SUBJECT: Forwards responses to draft Chemical Engineering Branch
 SER open Items 146 & 147 re schematics of sample lines &
 panels (per TMI Item II.B.3) & post-accident sampling sys.

SHEARON HARRIS NUCLEAR POWER PLANT
UNIT NOS. 1 AND 2
DOCKET NOS. 50-400 AND 50-401
DRAFT SAFETY EVALUATION REPORT RESPONSES
CHEMICAL ENGINEERING BRANCH

DRAFT SER OPEN ITEM 146

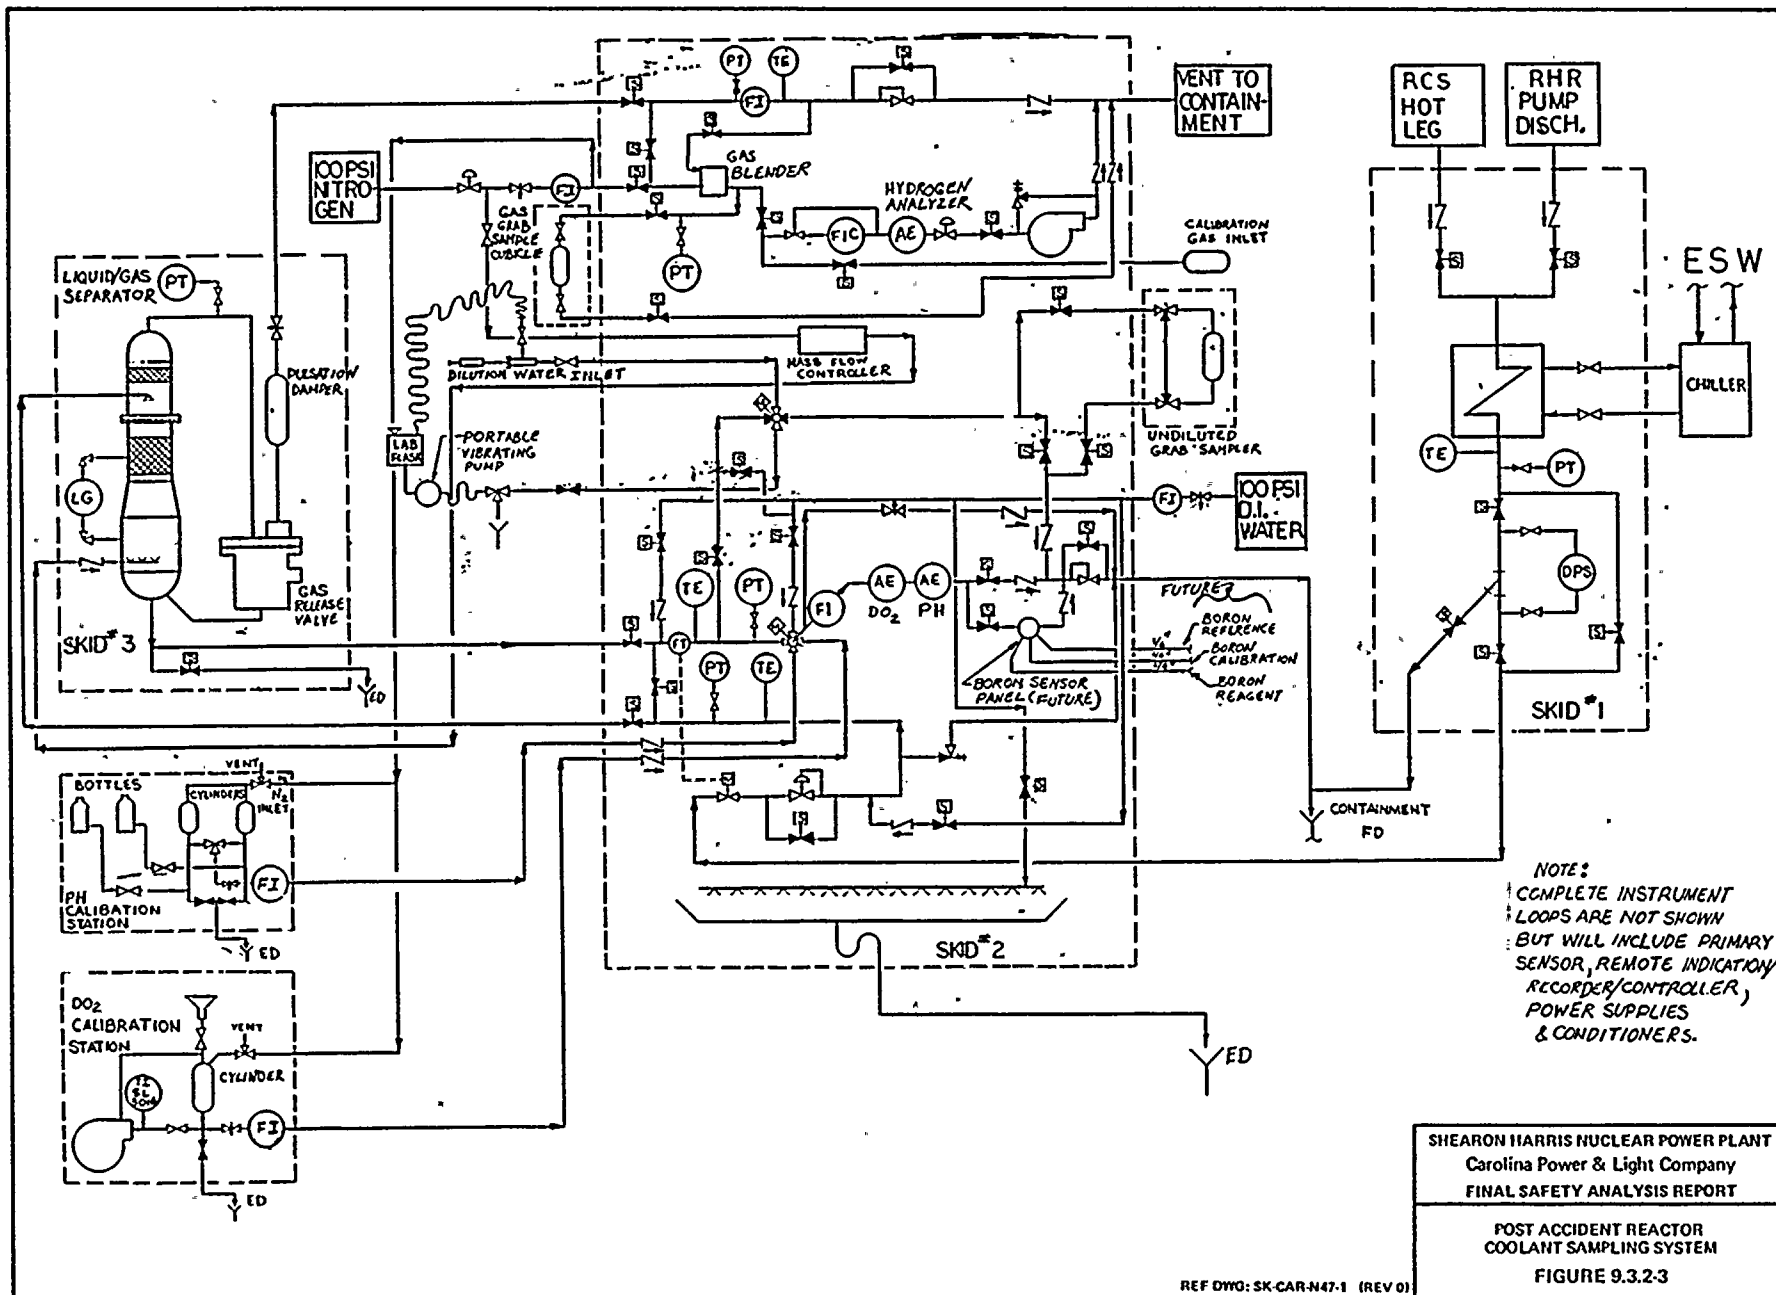
Provide the schematic diagrams of the sample lines and sampling panels.

Design criteria and capabilities of the Post Accident Sampling System comply with the guidelines of Item II.B.3 in NUREG 0737 and SRP 9.3.2 and are discussed in FSAR Section 9.3.2.2.3. The attached Figures 9.3.2-1 and 9.3.2-3 conceptually illustrate the sample lines and sampling panels, respectively.
